ADDENDUM

NO. 1

PROJECT NAME: Tomball ISD Intermediate School Replacement

ADDENDUM DATE: Tuesday, July 28, 2026

1 SECTION
S7.09 1/2" = 1'-0"

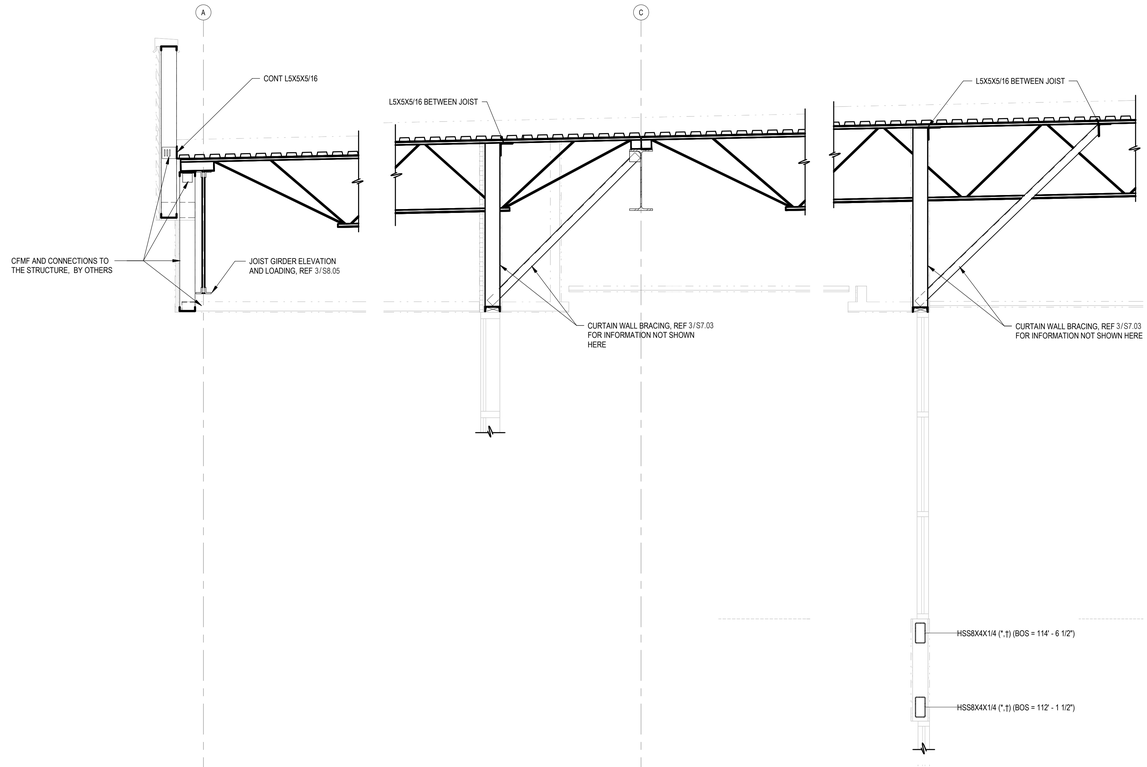
AD No 1, Struc. Item 11: To the Drawings, Sheet S7.09,"FRAMING DETAILS"
Revised detail.

1 SECTION
S7.16 1/2" = 1'-0"

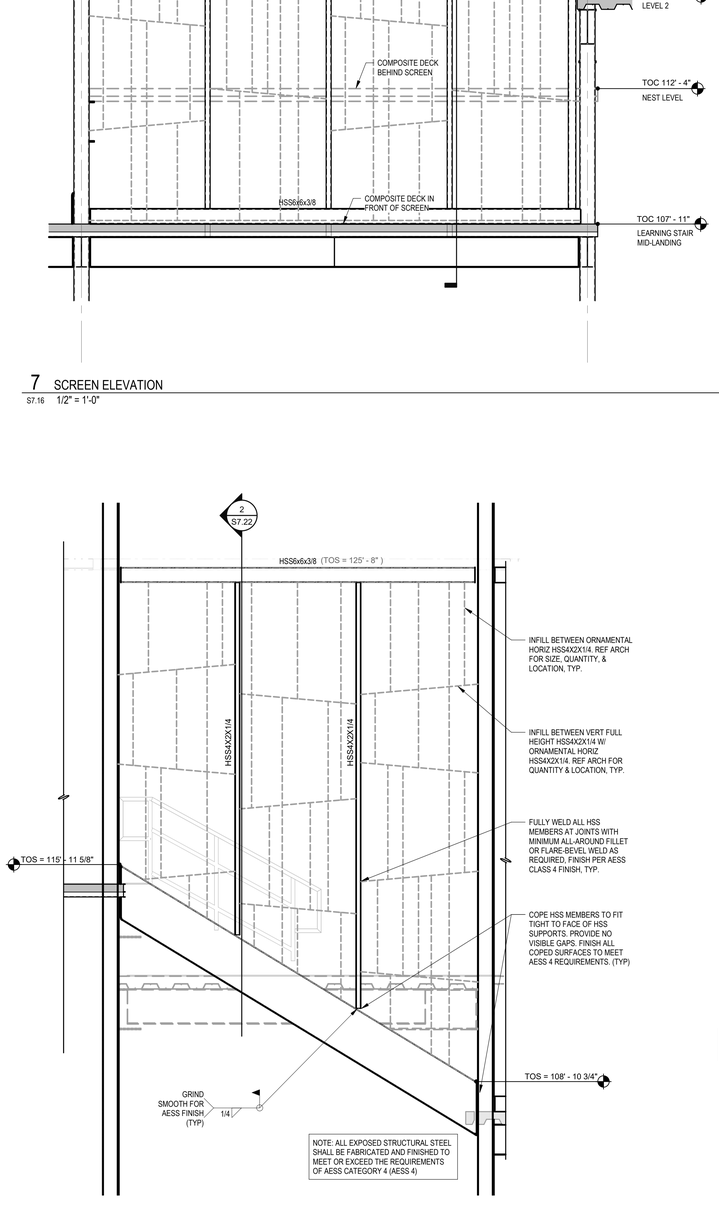
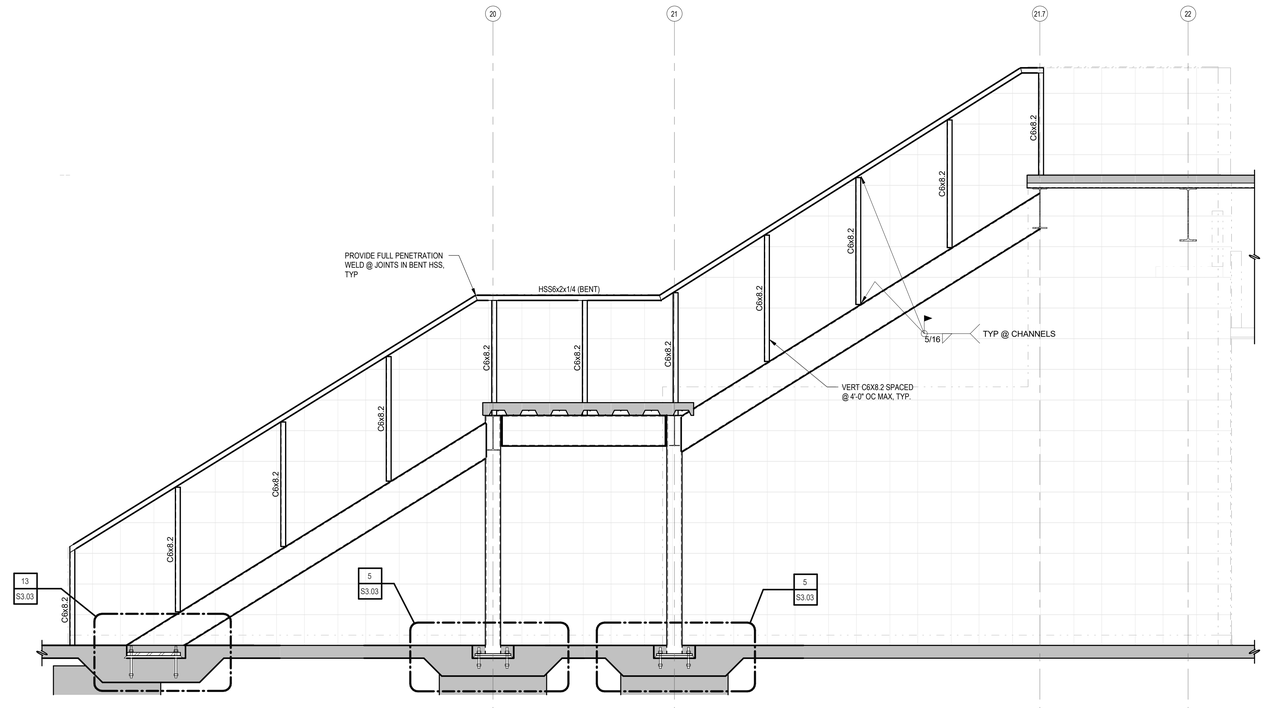
AD No 1, Struc. Item 13: To the Drawings, Sheet S7.16,"FRAMING SECTIONS"
Added, deleted, and revised details.

1 MASTER REFLECTED CEILING PLAN - LEVEL 01
1" = 20'-0"

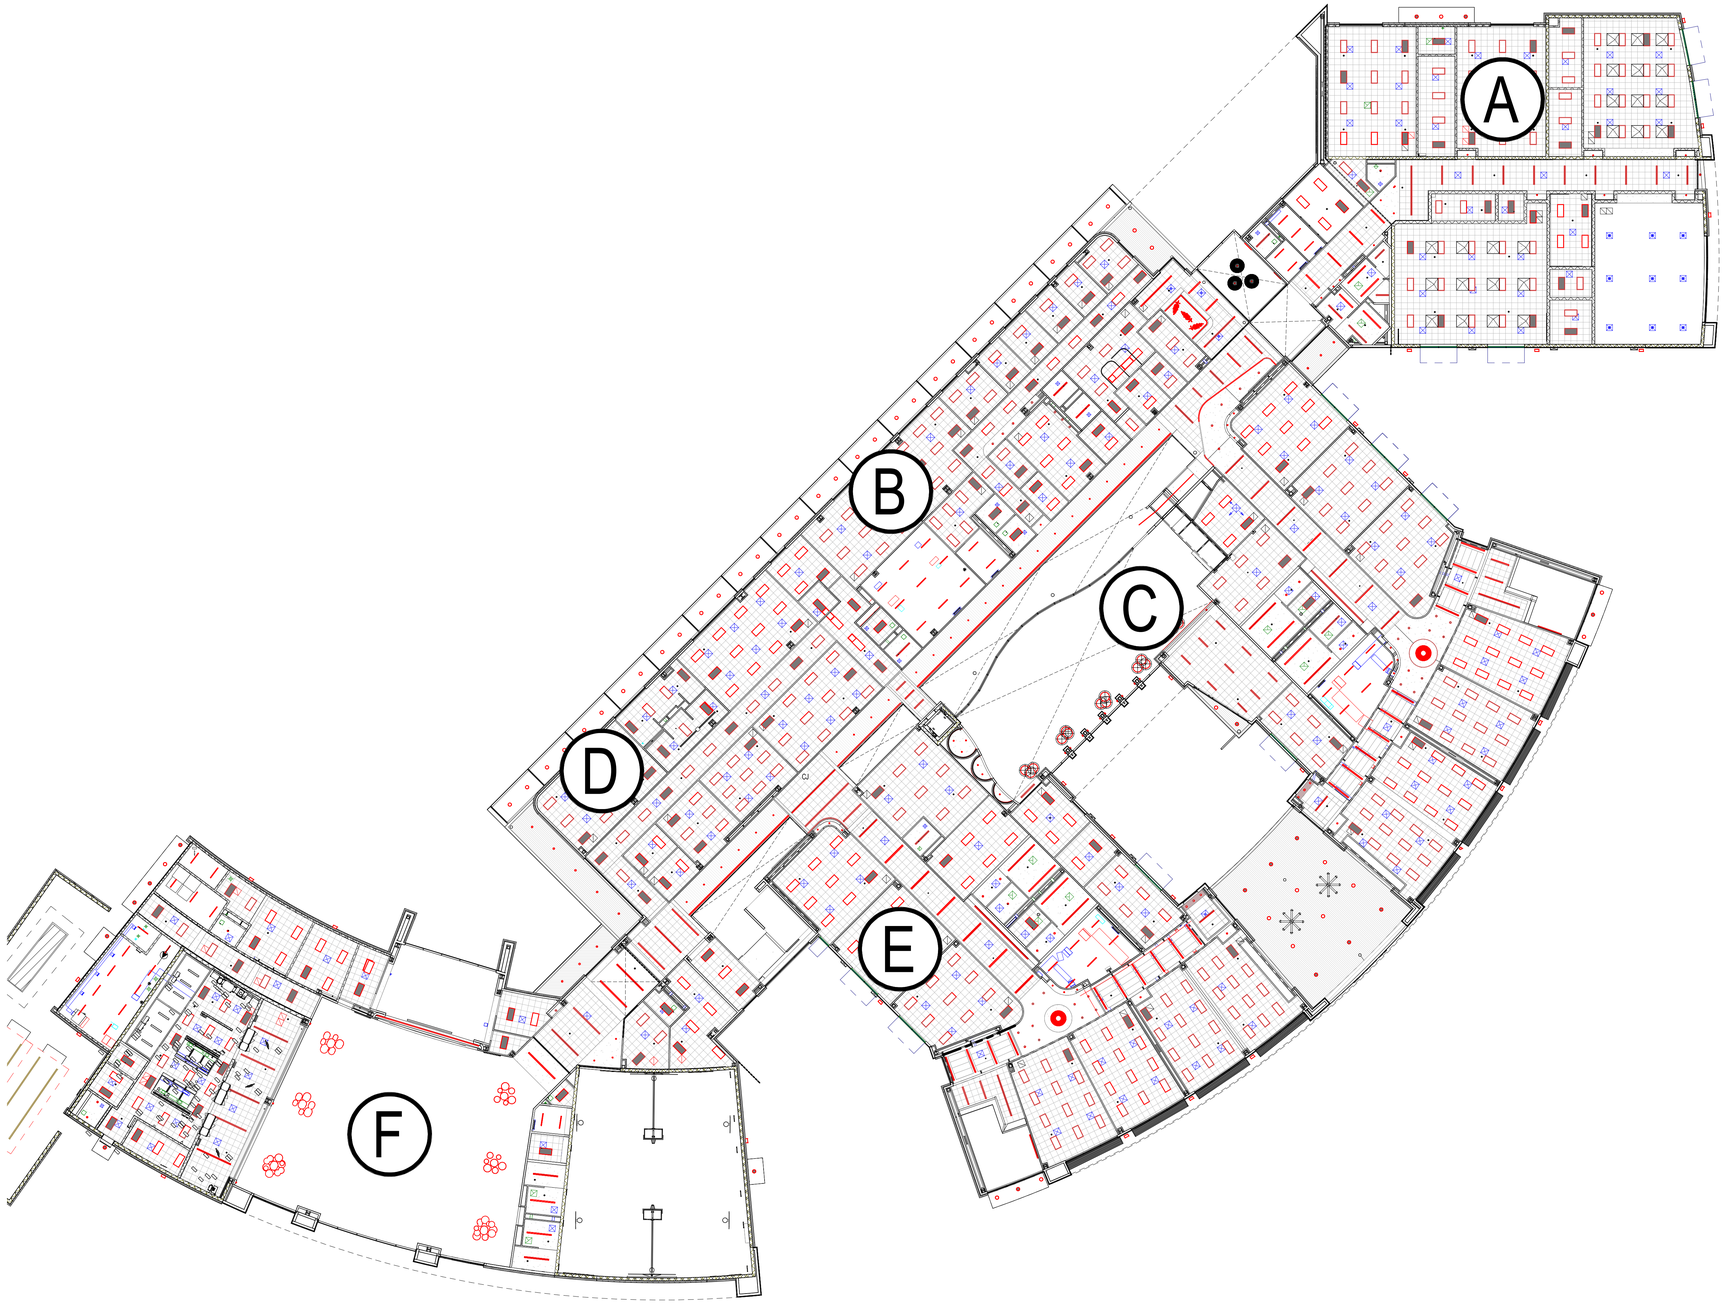
AD No 1, Arch. Item 8: **To the Drawings, Sheet A2.01,"MASTER REFLECTED CEILING PLAN – LEVEL 01"**
Added general note #6.

1 FINISH PLAN - LEVEL 02 - AREA B
1/8" = 1'-0"

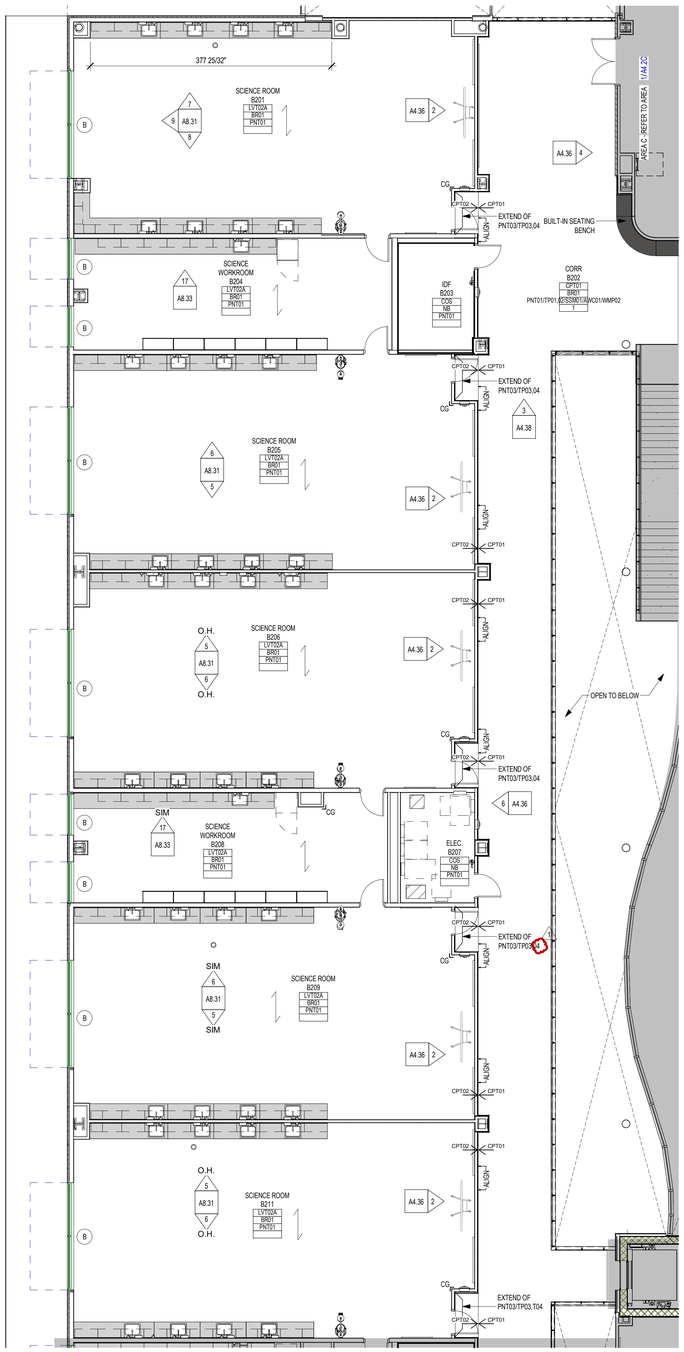
AD No 1, Arch. Item 12: **To the Drawings, Sheet A4.2B,"FINISH PLAN – LEVEL 2- AREA B"**
Revised tile annotation at alcoves. typical throughout project.
Revised FINISH PLAN GENERAL NOTES #10.

1 FINISH PLAN - LEVEL 02 - AREA C
1/8" = 1'-0"

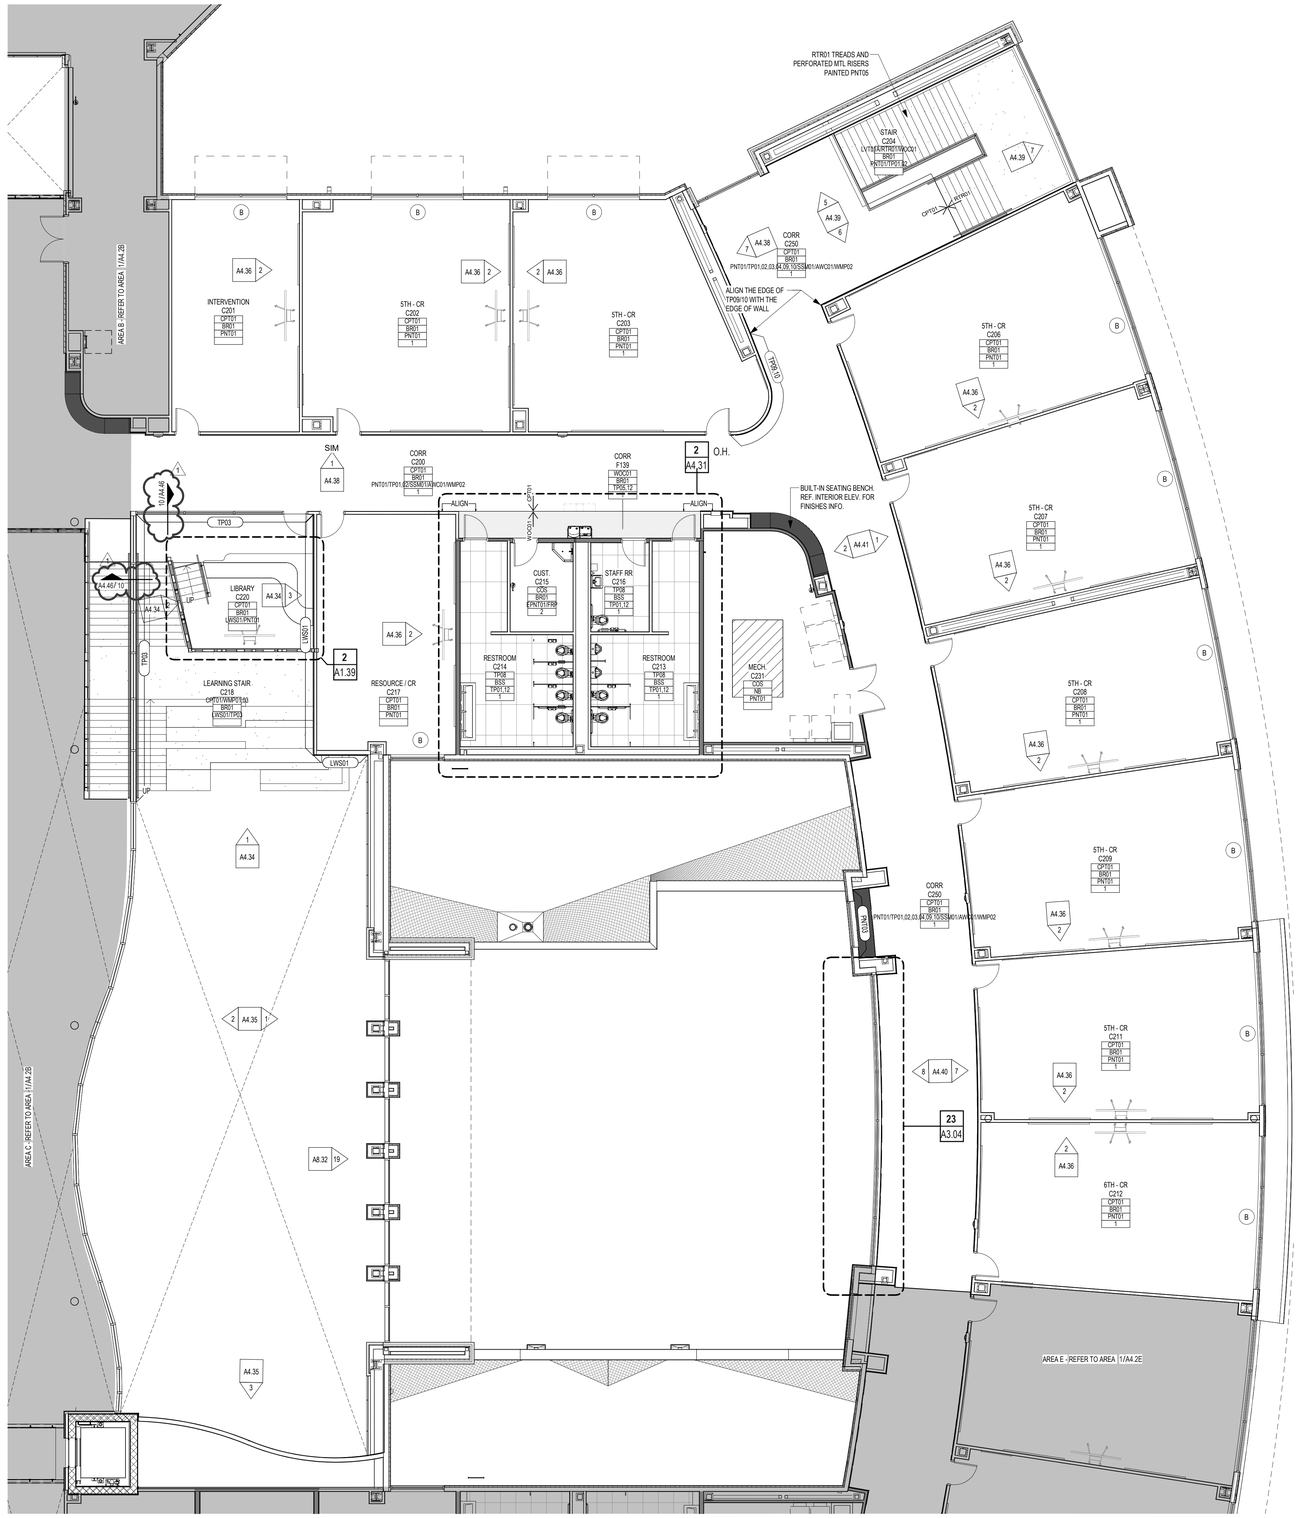
AD No 1, Arch. Item 13: **To the Drawings, Sheet A4.2C,"FINISH PLAN – LEVEL 2- AREA C"**
Added detail tags 10/A4.46 at tile sill.

5 INTERIOR ELEVATION - CORRIDOR - WEST
1/8" = 1'-0"

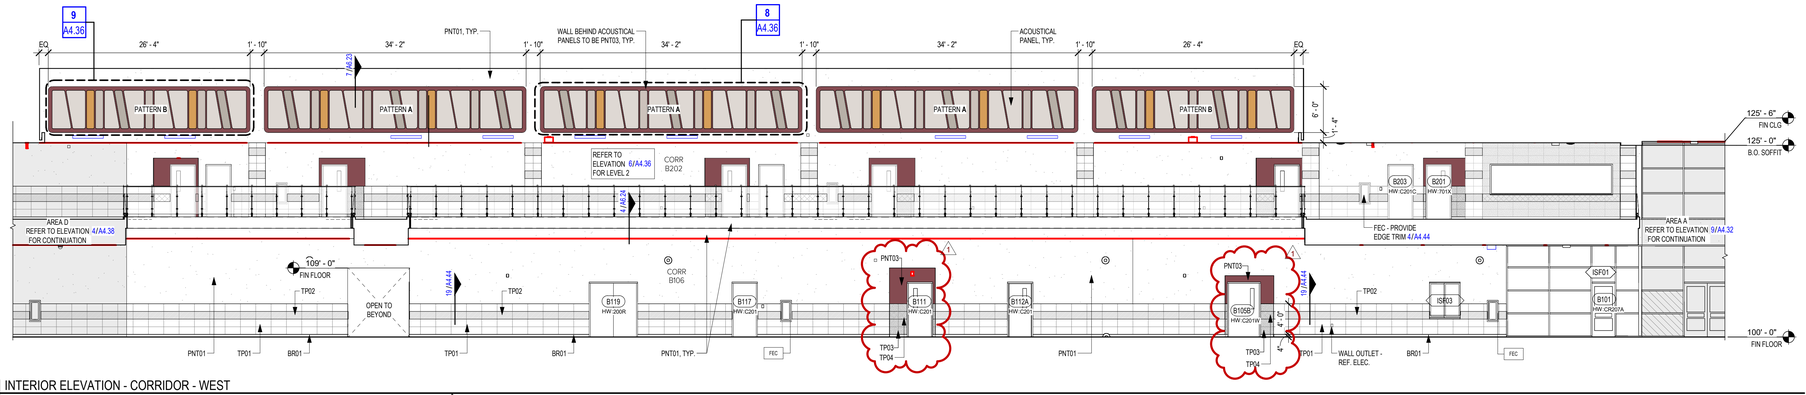
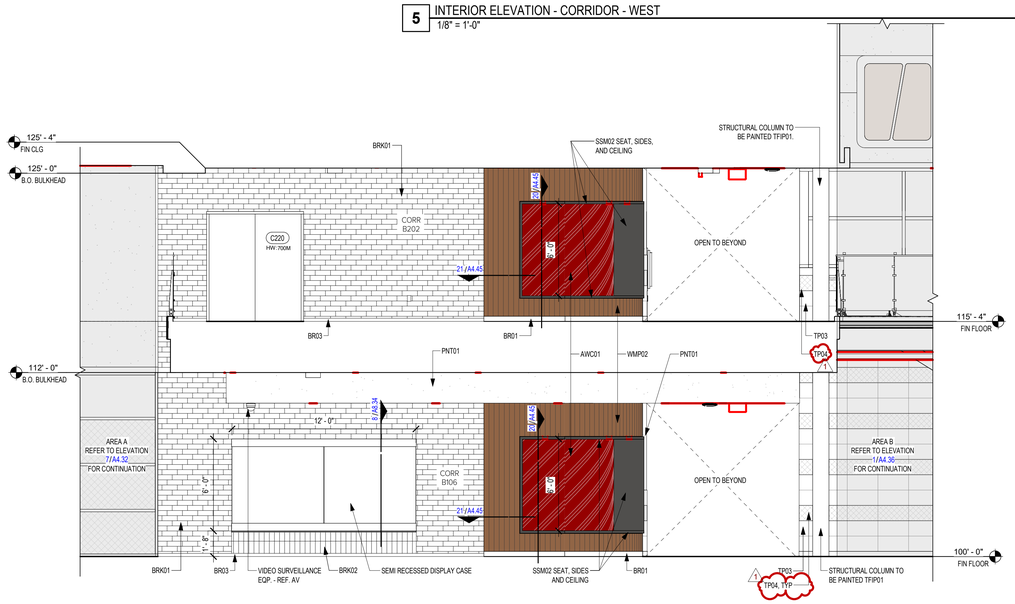
AD No 1, Arch. Item 15: **To the Drawings, Sheet A4.36,"INTERIOR ELEVATIONS"**
Revised elevation #1, # 4, #5, AND #6. Where TP03 field tile occurs TP04 to occur as accent, typical throughout project.

1 EQUIPMENT PLAN - LEVEL 02 - AREA B
1/8" = 1'-0"

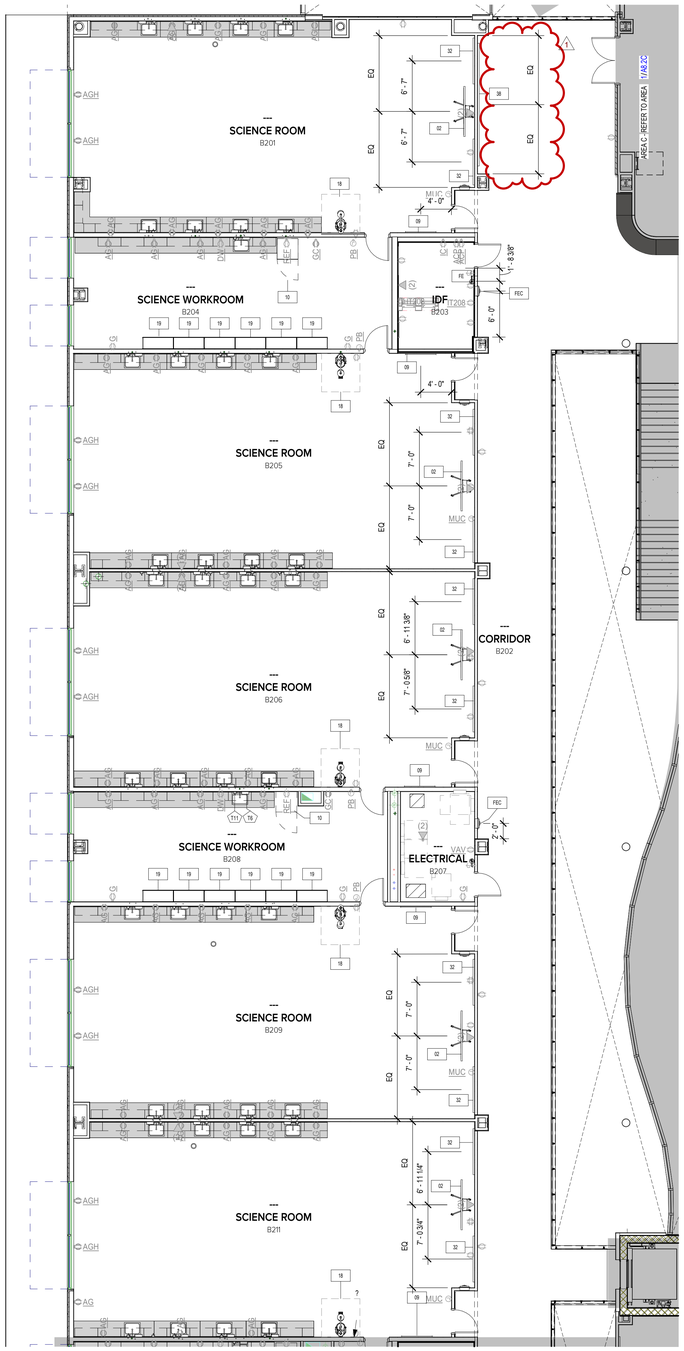
AD No 1, Arch. Item 19: **To the Drawings, Sheet A8.2B,"SIGNAGE AND EQUIPMENT PLAN – LEVEL 02 – AREA B"**
Added equipment item #38 to the equipment schedule and the plan.
